SUBJECT: COMANCHE PEAK STEAM ELECTRIC STATION
DOCKET NOS. 50-445 AND 50-446
SUPPLEMENT TO LICENSE AMENDMENT REQUEST (LAR) 07-003
RESPONSE TO REQUEST FOR ADDITIONAL INFORMATION RELATED TO REVIEW
ASSOCIATED WITH LARGE AND SMALL BREAK LOCA ANALYSES
(TAC Nos. MD6212 and MD6213)

REQUEST FOR ADDITIONAL INFORMATION RELATED TO
REVIEW ASSOCIATED WITH LARGE AND SMALL BREAK LOCA ANALYSES

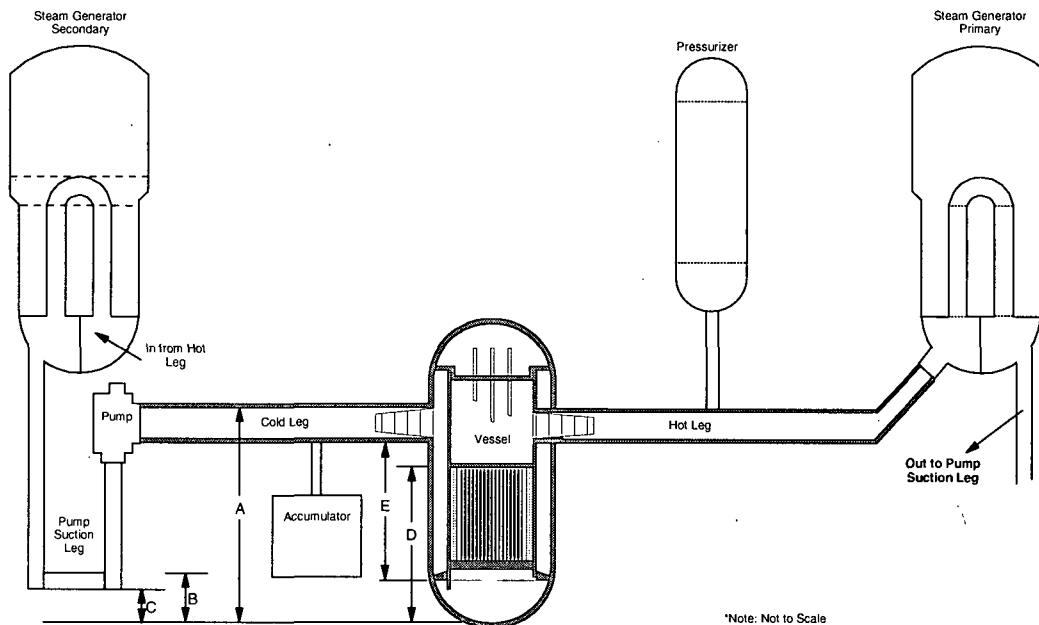
- b) Elevations of the top of the RCP discharge leg, the bottom of the suction leg, and top of the core.

A	Elevation of top of RCP discharge leg	28.49**	ft
B	Elevation of the top of the suction leg	18.32**	ft
C	Elevation of the bottom of the suction leg	15.74**	ft
D	Elevation of the top of the core	22.08**	ft

** Referenced from inside bottom of reactor vessel

Please refer to the following figure for the definitions of A-D in the above table:

Figure 1
Specific Gravity of Boric Acid – Water Solutions^[1]

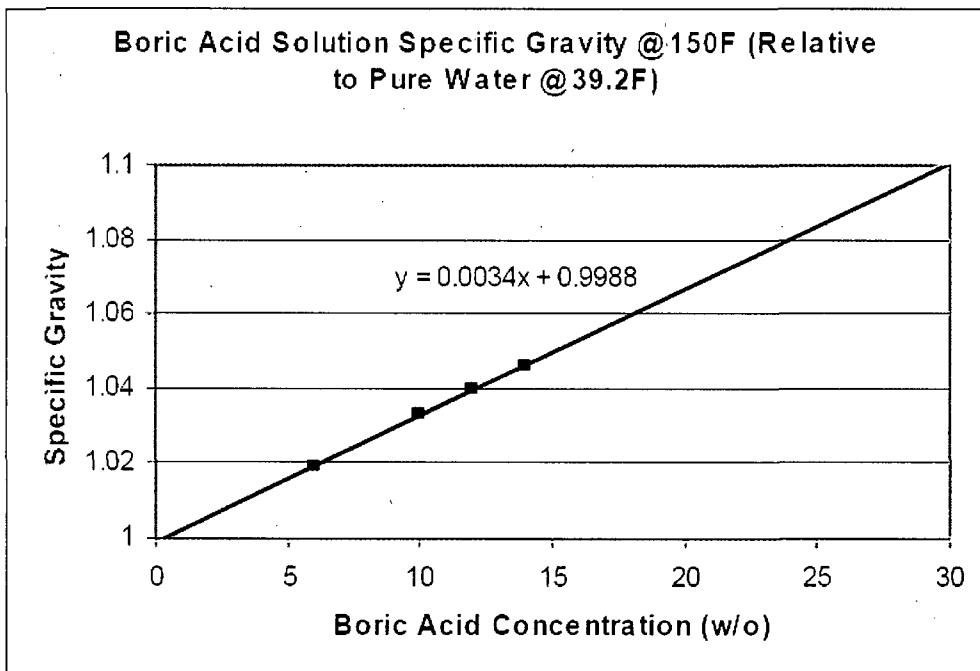
- 22. In the long term cooling analysis for boric acid precipitation, did the calculations include the density effect of the boric acid in the mixing volume? This will delay the increase in mixing volume vs. time in the vessel and increase the boric acid concentrations during the first two hours following the LOCA.**

The increased density of the boric acid solution was considered in calculating the mass of the liquid in the mixing volume. The increased density of the boric acid solution on core region mixing volume was not modeled as explained below.

Since the density of a boric acid/water solution increases with percentage of boric acid, there would be a liquid density difference between the core and downcomer. This density difference would be small early in the transient and would increase as the boric acid concentration increases in the core. There may also be some small offsetting density differences due to core/downcomer temperature differences. The net effect of a higher core liquid density as compared to the downcomer would be a lower flooding rate later in the boric acid concentration transient, well after core quench has occurred. The effect of downcomer-core density differences on the core and upper plenum liquid volume can be estimated using the boric acid concentration versus specific gravity plot shown in Figure 1. A 10 wt% boric acid solution has a specific gravity approximately 3% greater than the 1 wt% boric acid solution that would be in the downcomer. Based on a 60% core void fraction and a 30 wt% boric acid solution in the core, the core region liquid volume would be approximately 5.4% lower than otherwise predicted if this density difference is not recognized. This difference in mixing volume is small in comparison to the conservative mixing volume margin used in the analysis.

Density differences (due to temperature or boric acid concentration) would have a beneficial effect on mixing. An increase in the core fluid density due to concentration of debris and chemicals will result in unstable configuration leading to natural convection flow patterns between the core and the less dense lower plenum, which will limit the density buildup. This was demonstrated in the BACCHUS test results previously provided to the NRC in Reference 2.
